Interactive comment on “Simulation of transient gusts on the NREL5 MW wind turbine using CFD” by Annika Länger-Möller

Received and published: 12 January 2018

Fig. 1. Grid resolution

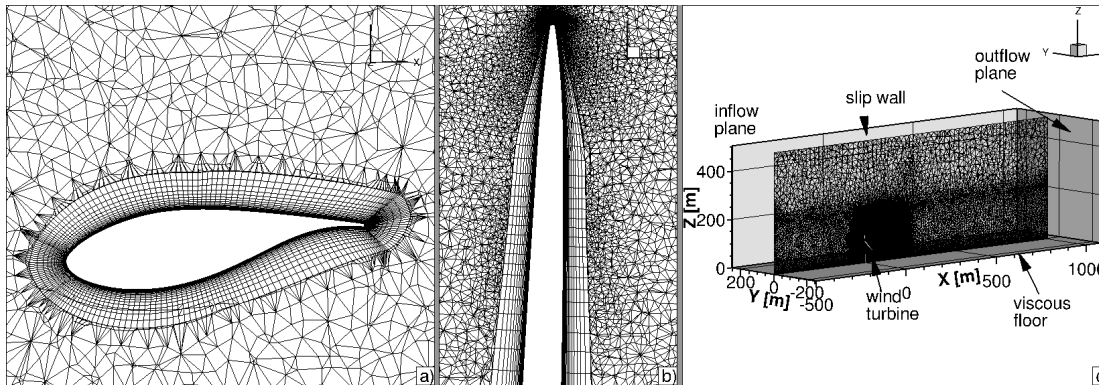
- RC: *Generally the figures are very small, and Figure 1 about the grid set-up is basically of no use and should be replaced.*

- RC: *More illustrative figures showing the chord-wise and span-wise resolution should be included, along with a cut through the full grid topology.*
AC: See section Figures, first bullet point.

AC: I enlarged the figure. Moreover I changed the content to represent the chord-wise distribution, span-wise distribution in the blade tip region and the meshing topology in the farfield. Please see figure 1 of my response.

Fig. 2. pressure coefficient and friction force coefficient

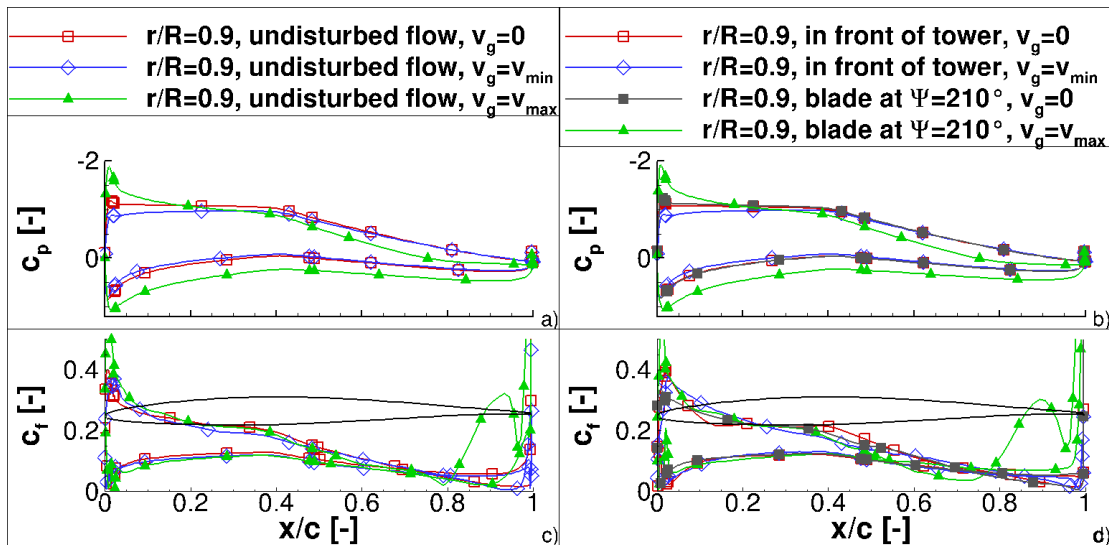
- RC: *The C_p and C_f plots, Fig. 7,8,9,10, 11 and 12 are very small and not providing that much information.*

AC: I enlarged figure 7 to 12 and summarized them into 3 figures to enable a better comparison between no tower/tower blockage. I added one exemplary figure to my response. The descriptive text in the paper changed accordingly. Please see figure 2 of my response.

Fig. 3. radial distribution of rotor thrust and torque

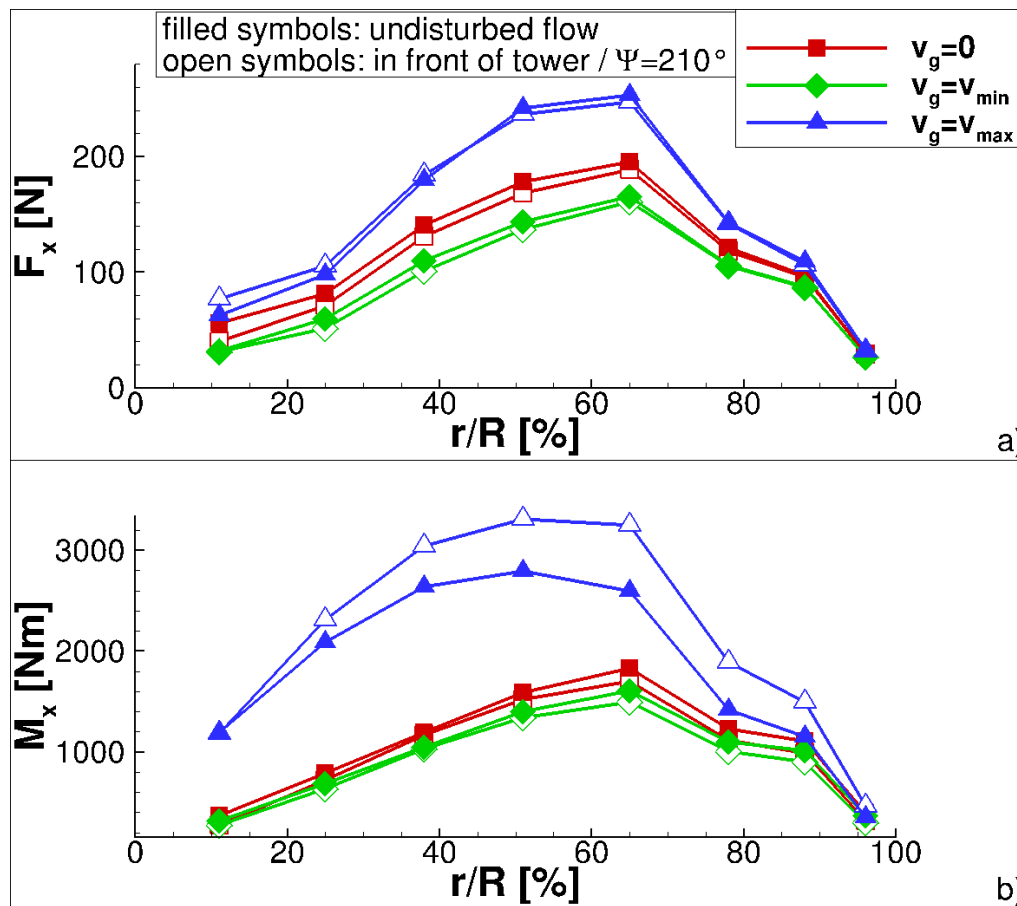
- RC: *They could be exchanged with plots of radial force distributions at $[0,90,180,270]$ degrees azimuth. Eventually, a blow-up of the C_f distribution could be included to assist the discussion about separation versus no separation.*

- RC: *Generally, the pressure distributions add very little information to the discussion, and should be replaced by span-wise force distributions.*
AC: Thank you for the suggestion. I prepared figures of the span-wise force distribution and added them to the paper. It is also attached to my reply. In the paper, a new paragraph is added to section 5.3. Please see figure 1 of my response.

AC: I added a plot of the radial distribution of rotor thrust and torque to the paper. Please refer to section Results, bullet-point 1 for further information.

Fig. 4. vortex transport parallel to flow direction in dependency of vortex age

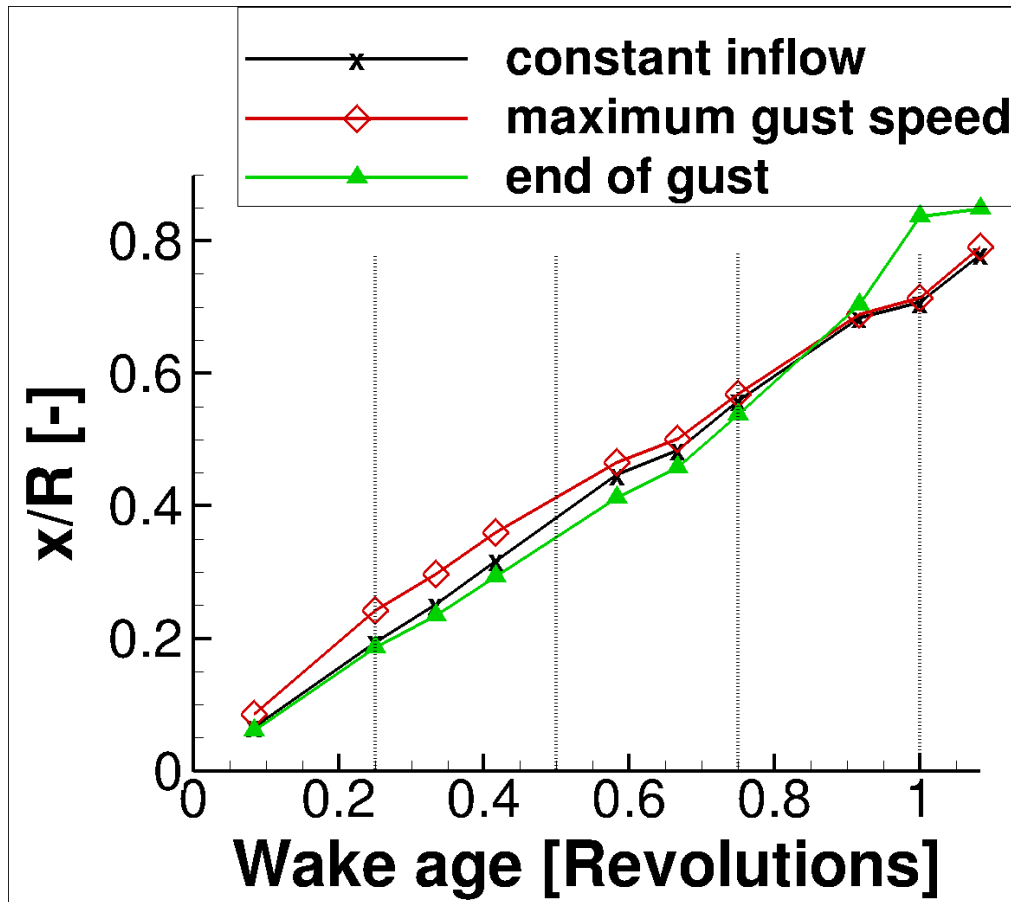
- RC: *Figure 13 on the tip vortex movement is very hard to interpret, as we do not know if the rotor is at identical azimuth positions for the different snap-shots.*
AC: Yes, the instances were taken at identical azimuth positions. This information is added to section 5.3.

- RC: *It would maybe be more interesting to show the axial and radial location of the tip-vortex as function of vortex age at the three instances in time.*
AC: I changed figure 14 accordingly to your suggestions and added a plot of the axial and radial location of the tip vortex as function of vortex age. Conversely, I only changed the colouring of figure 13 from blue to red. I attached the figures to give you an impression. The description of the figures changed accordingly in section 5.3. Please see figure 4 of my response.
